J2127A-01

S E R V I C E N O T E

Agilent J2127A Transmission Test Set

Failure of Optical Covers

J2127A Instrument Panel - Reverse

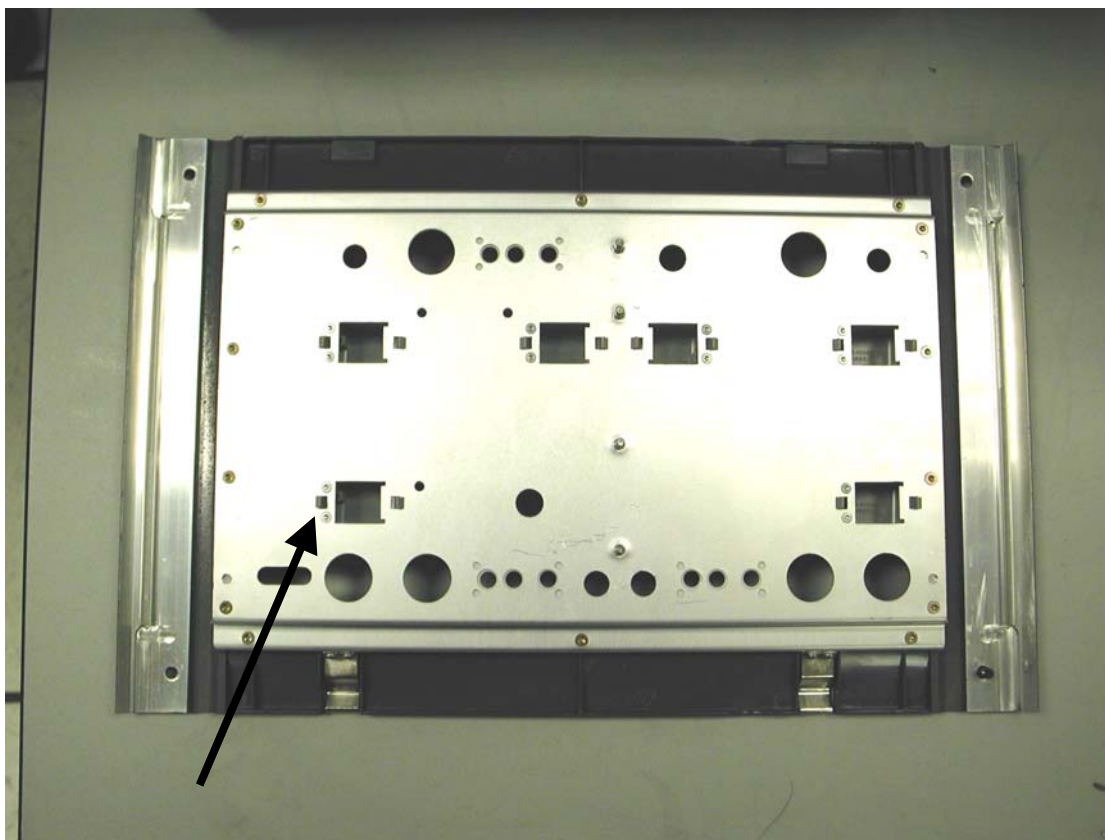
Early shipments of the J2127A Test Sets have a design problem with the optical covers, which makes them prone to cracking.

1. Remove the instrument top panel by unscrewing the four corner screws.
2. Lift off the instrument top panel.
3. Each optical cover is secured to the instrument top panel by a lip on each leg of the cover and also by two screws attached to the base of each cover. See the example arrowed in the illustration below.

Replace all existing covers with new, more rugged cover.

4. Remove the two screws from each cover first and then lever free one lip of the cover.
5. The cover should then lift free from the instrument panel.

6. Remove all the remaining covers.
7. Fit the replacement covers by performing the reverse of steps 4 to 6 taking care to position the covers as described below. Ensure the screws on the cover are tightened to a torque of 0.15nm maximum.

Optical Port Cover	Locate Cover with hinge
52M-2.5G 1550nm OUT	Left
52M-2.5G 1310nm OUT	Left
52M-622M IN	Right
2.5G IN	Left
10G 1550nm OUT (J2127A only)	Left
10G IN (J2127A only)	Left

Instrument ESD Inserts

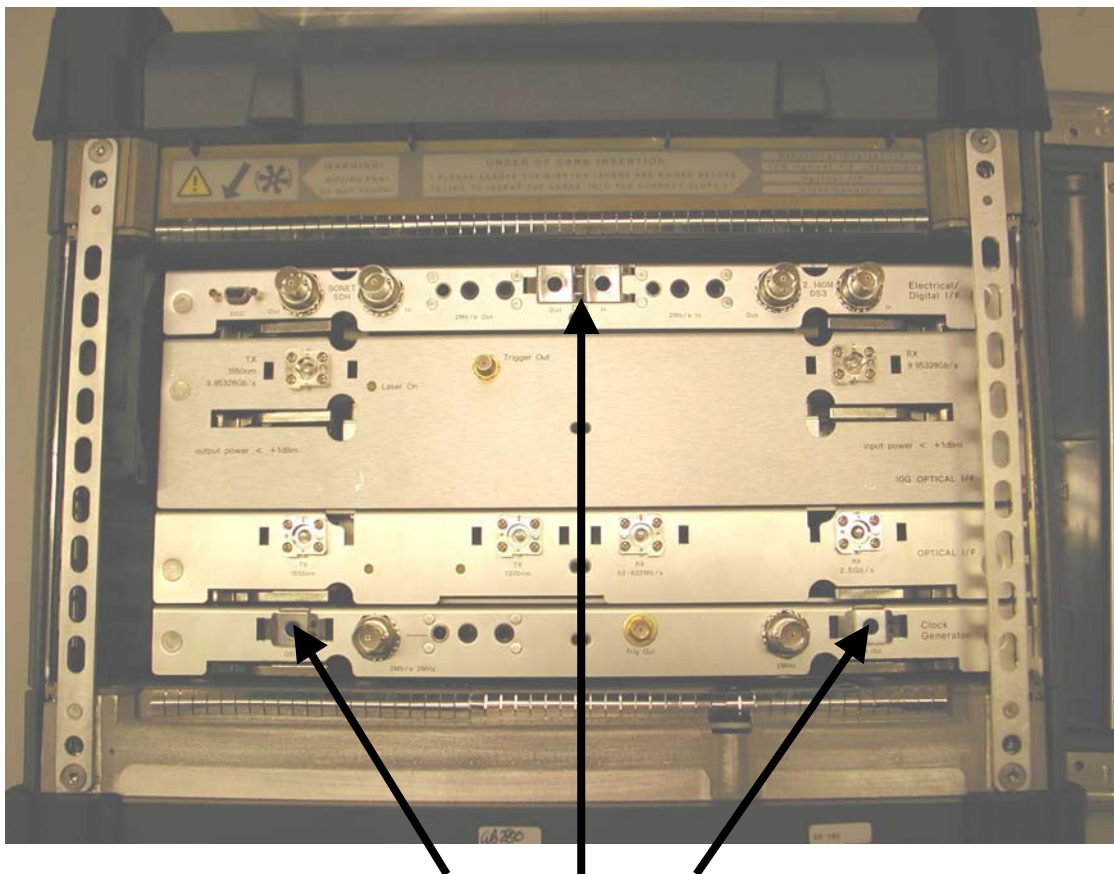
8. Before re-fitting the instrument top panel perform the following checks.
 - a) Check ESD inserts, as shown below, are properly aligned with the DS1 connector sockets.

- b) Replace any damaged inserts, using a suitable tool, such as narrow tweasers.
 - c) When removing any ESD inserts, lever out one side first and lift out the insert.
 - d) To fit a new insert locate one side of the insert first, then locate the other side.
9. Re-check the ESD insert alignment and then refit the instrument top panel.
 10. Ensure the screws securing the instrument top cover are tightened to a torque of 2.8Nm
 11. Finally, using a DS1 Bantam plug, check that there is no friction from the ESD insert as the plug is inserted into each of the DS1 sockets.
 12. End of procedure.
